Planning Commission Date: May 23, 2007 Item No. 2.

MILPITAS PLANNING COMMISSION AGENDA REPORT

TITLE:	**USE PERMIT NO. UP2007-5 and "S" ZONE APPROVAL NO. SA2007-5**
Proposal:	A request for a new sign program, which includes installation of a new monument sign at the corner of McCarthy Boulevard and Sumac Drive for the SanDisk corporate campus.
Location:	601 McCarthy Boulevard (APN: 086-02-039) and 900 to 1100 Sumac Drive (APN: 086-01-037, 039, 040)
RECOMMENDATION:	**Approval with conditions**
Applicant:	SanDisk Corporation, 601 McCarthy Blvd., Milpitas, CA 95035
Property Owner:	RREEF, 3303 Octavius Drive #102, Santa Clara, CA 95054
Previous Action(s):	"S" Zone approval and amendments
Environmental Info:	Exempt from CEQA pursuant to Section 15311 (Accessory Structures)
General Plan Designation:	Industrial Park
Present Zoning:	Industrial Park with "S" Combing District (MP-S)
Existing Land Use:	R&D Buildings
Agenda Sent To:	Applicant/Owner
Attachments:	Plans
PJ No.	2484

Sign (E) PROPOSED

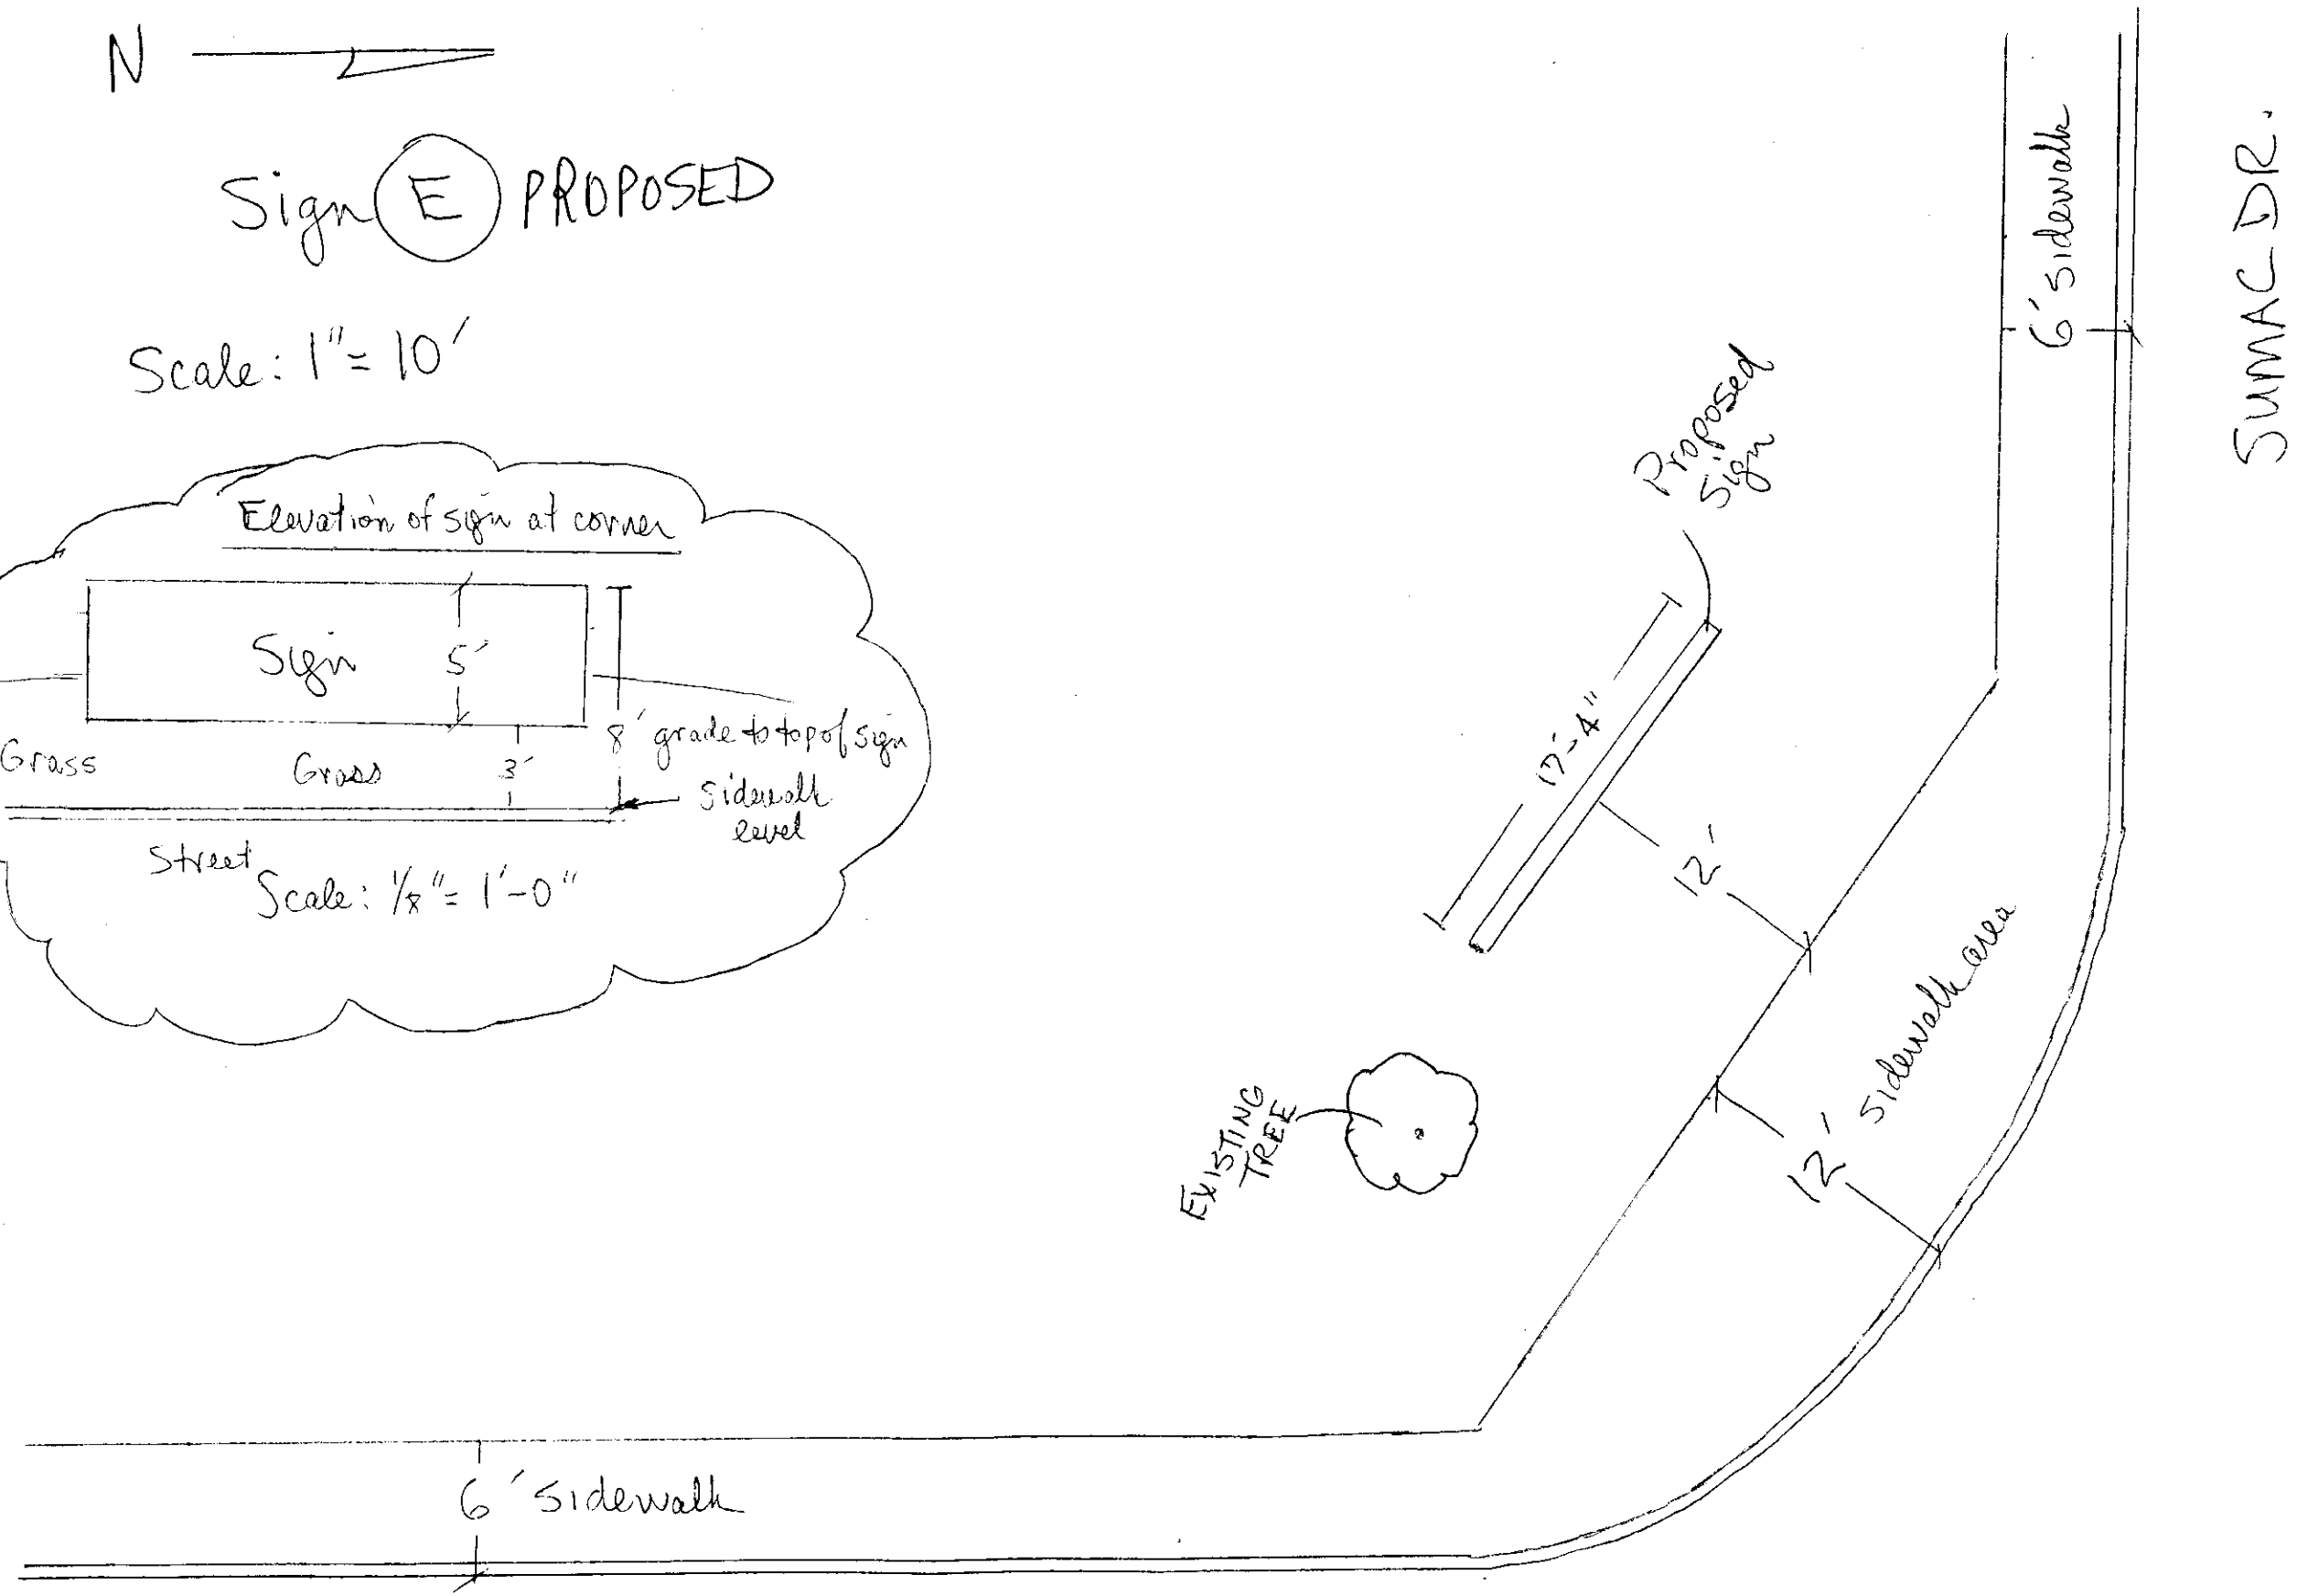
4. The applicant shall incorporate additional landscaping at the base of the monument sign at the corner of McCarthy and Sumac to the approval of the Planning Division. (P)

7. The developer shall not obstruct the noted sight distance areas as indicated on the City standard drawing #405. Overall cumulative height of the grading, landscaping & signs as determined by sight distance shall not exceed 2 feet when measured from street elevation. (E)

8. City records, although not conclusive, shows an existing 18" private storm drain line at the corner of the Sumac and McCarthy Boulevard serving this site. Construction plan should show the location the existing storm drain line and indicate the protection measure taken to keep the line in place. (E)
